RE: Revised Application Deficiency Report #4 - Certificate of Public Convenience and Necessity for the Riverside Transmission Reliability Project – Application No. A.15-04-013

DEFICIENCY REPORT #4 (REVISED) FOR THE RIVERSIDE TRANSMISSION RELIABILITY PROJECT APPLICATION (A. 15-04-013)

Table 1: SCE Riverside Transmission Reliability Project Application 15-04-013 Deficiency Report #4 (Revised 09/22/2016)

-  ROW
-  Lattice Structure
-  Tube Structure
-  Proposed Transmission Line
-  Indicative Access Road
-  GDAD Buffer Area
-  Land and Water Conservation Fund
-  Freshwater Emergent Wetland
-  Freshwater Forested/Shrub Wetland
-  Riverine

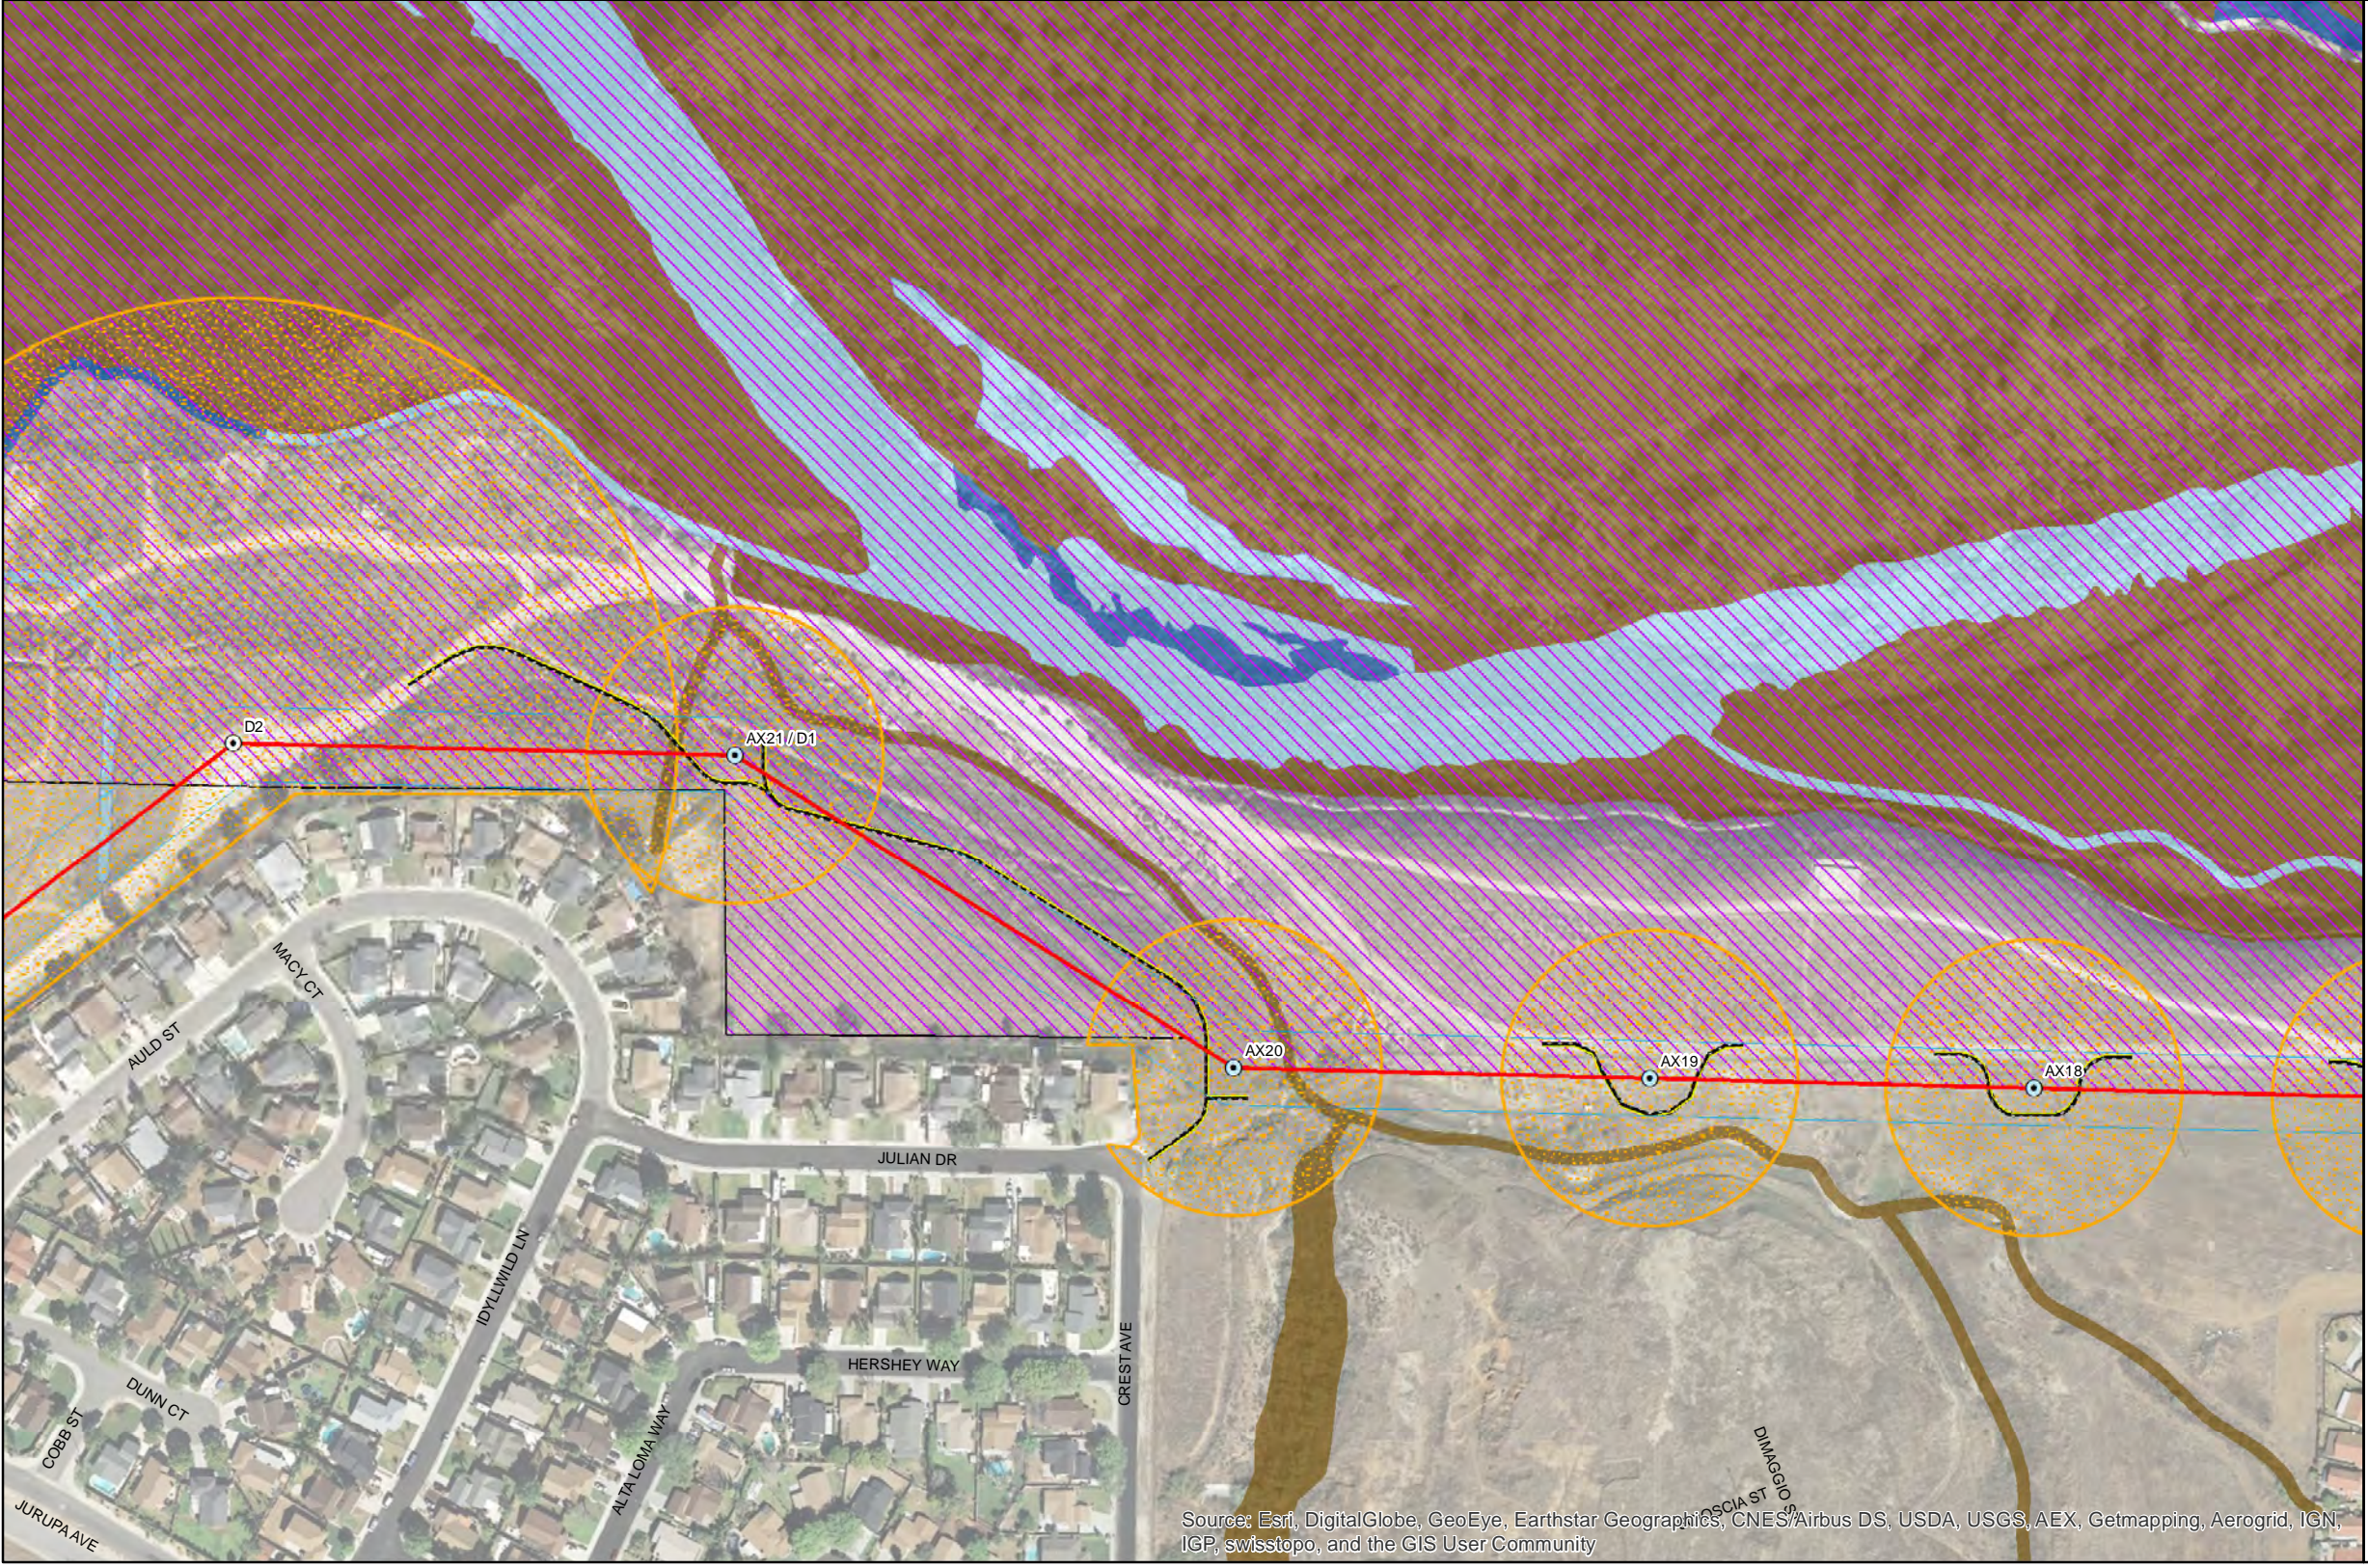
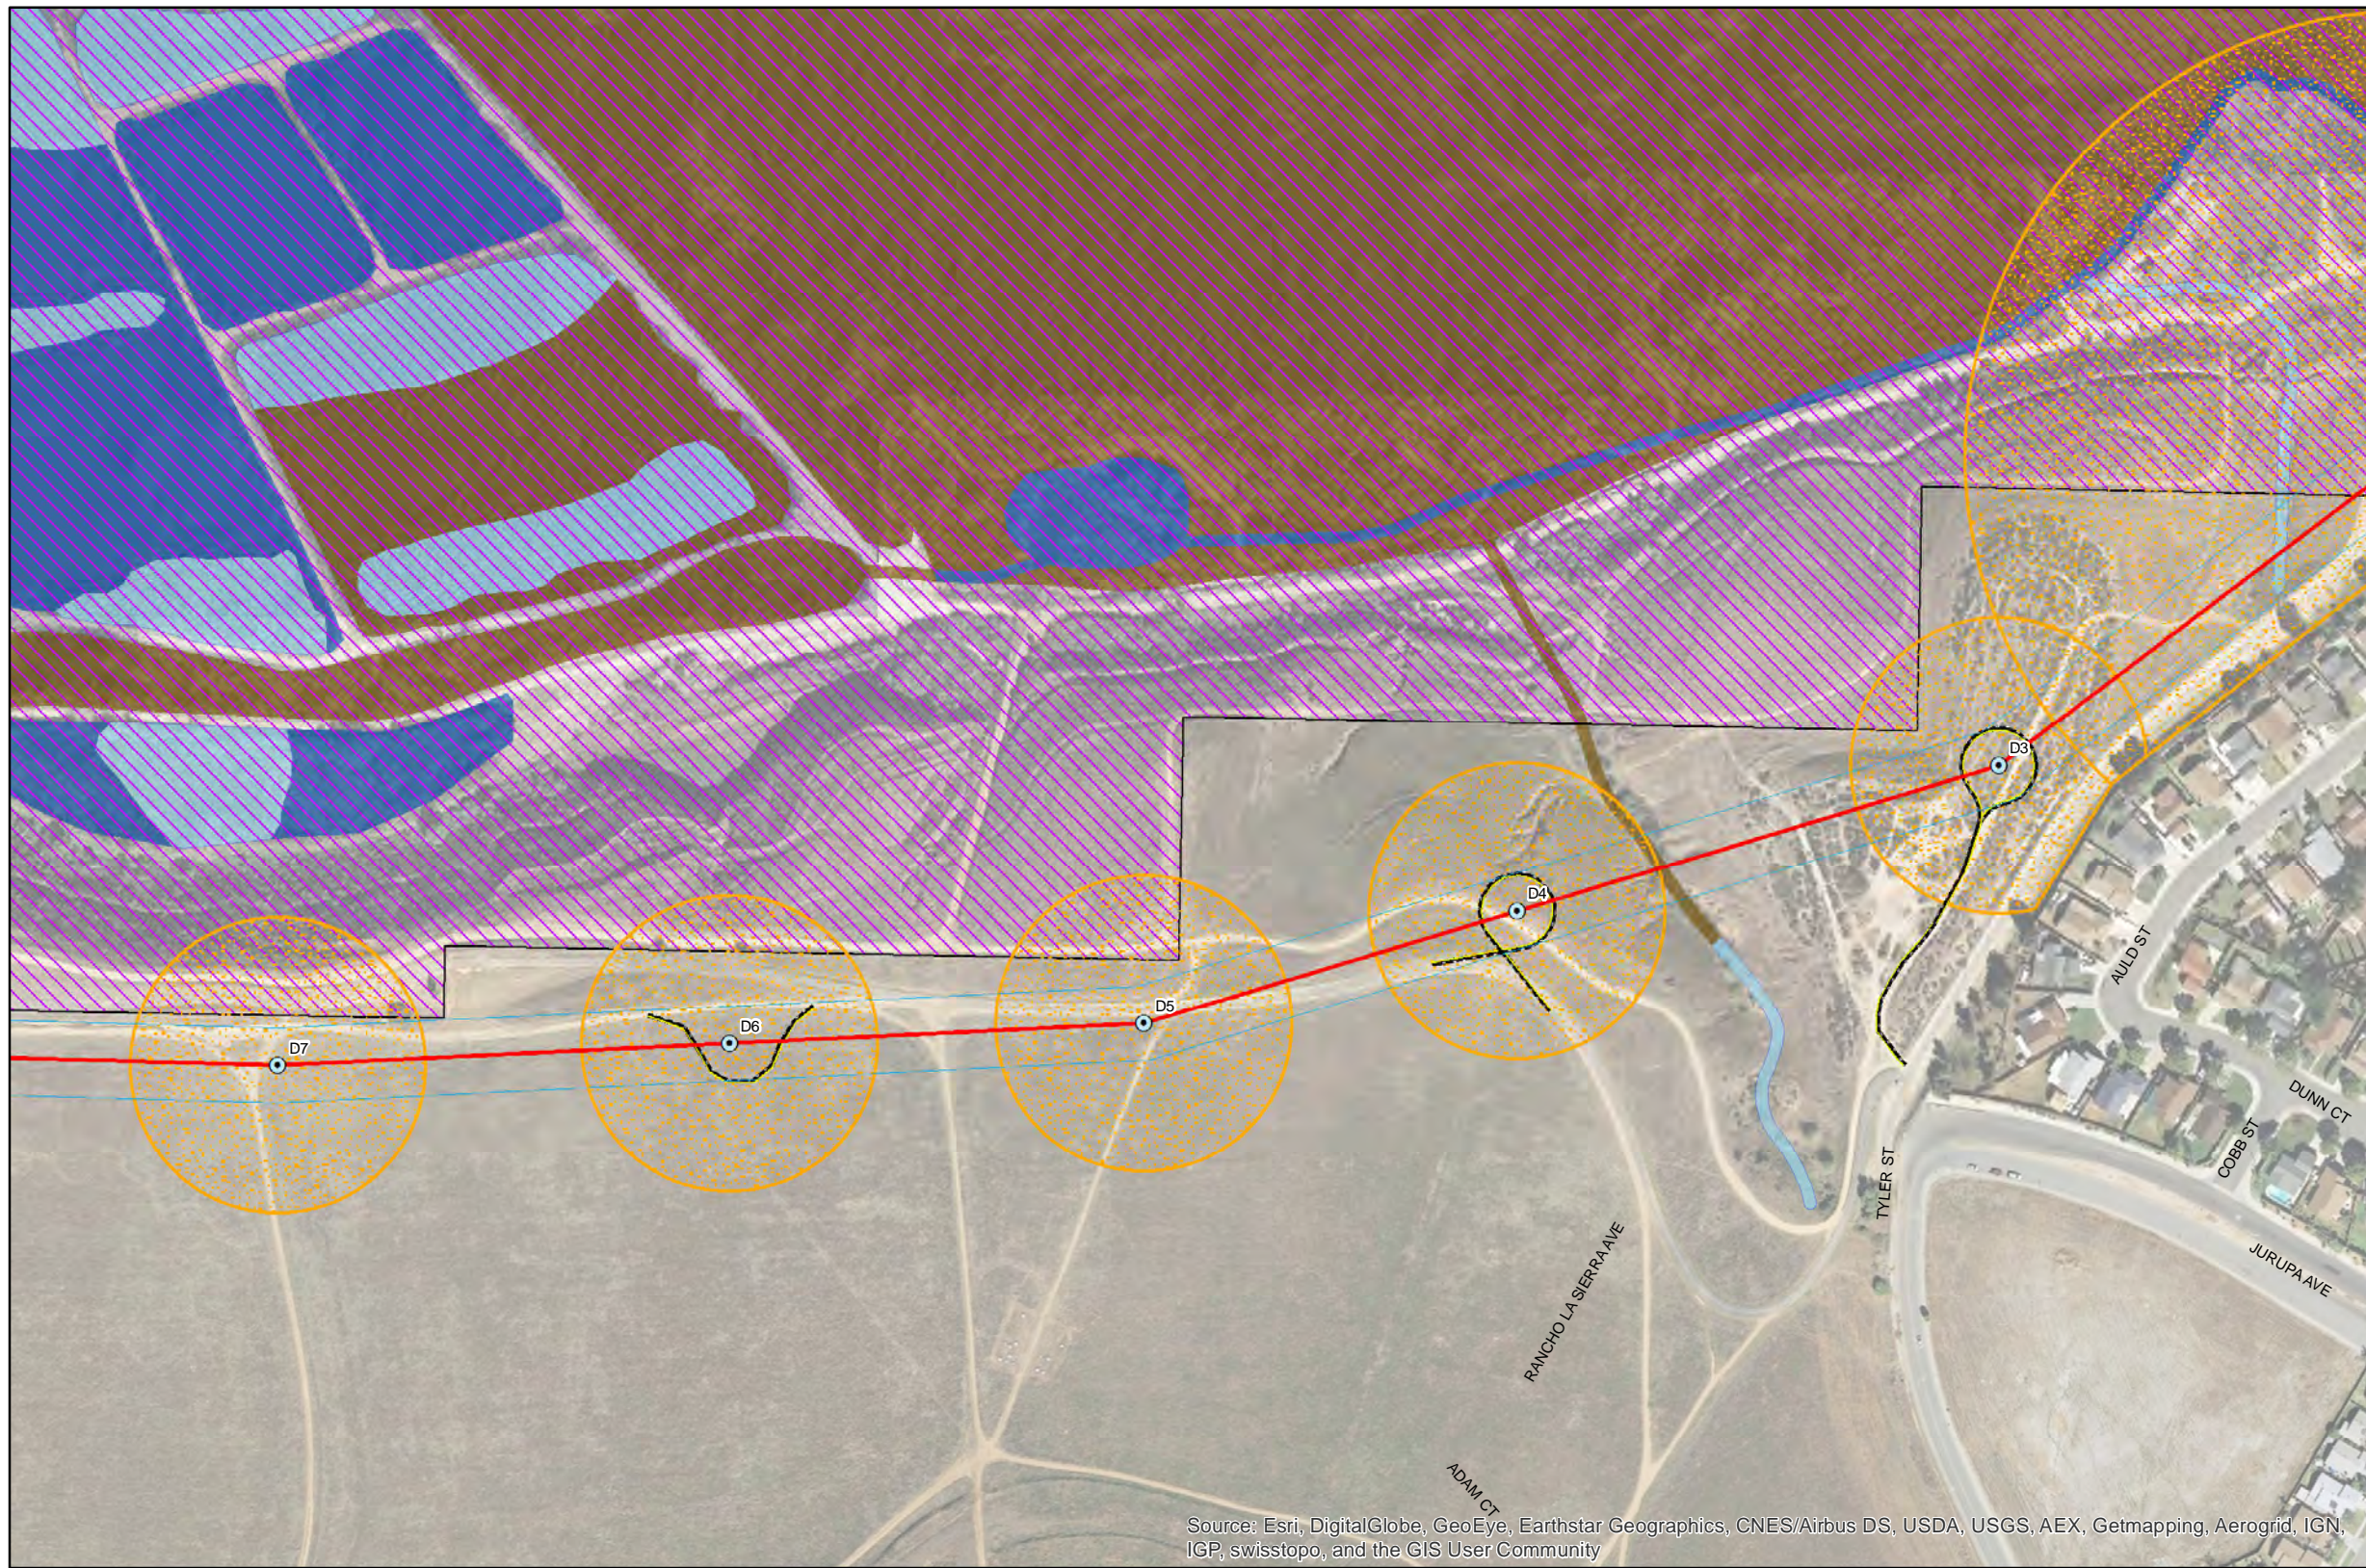
Number	Information Requested Previously?	Deficiency
		<p>The CPUC has prepared a mapbook (Attachment A) showing locations where the proposed buffer areas overlap with the following facilities and resources within the overhead alignment southeast of the Santa Ana River:</p> <ul style="list-style-type: none"> • Steep slopes • Wetlands including the Santa Ana River floodplain and/or tributary drainages • Metropolitan Water District's aqueduct infrastructure • City streets, parking lots, loading/receiving docks, and perimeter landscaping of adjacent buildings • Riverside Water Quality Control Plant facilities • Hidden Valley Wilderness Area (federal land and water conservation fund area) <p>These resources should be avoided and carved out of the work area buffers, where feasible.</p> <p>The revised preliminary engineering plans and detailed route maps should also depict alignment revisions including the proposed underground alignment along Pats Ranch Road and 68th Street, and revised overhead alignment north of Limonite Avenue.</p> <p>Please include GIS data files for all detailed route map refinements.</p>
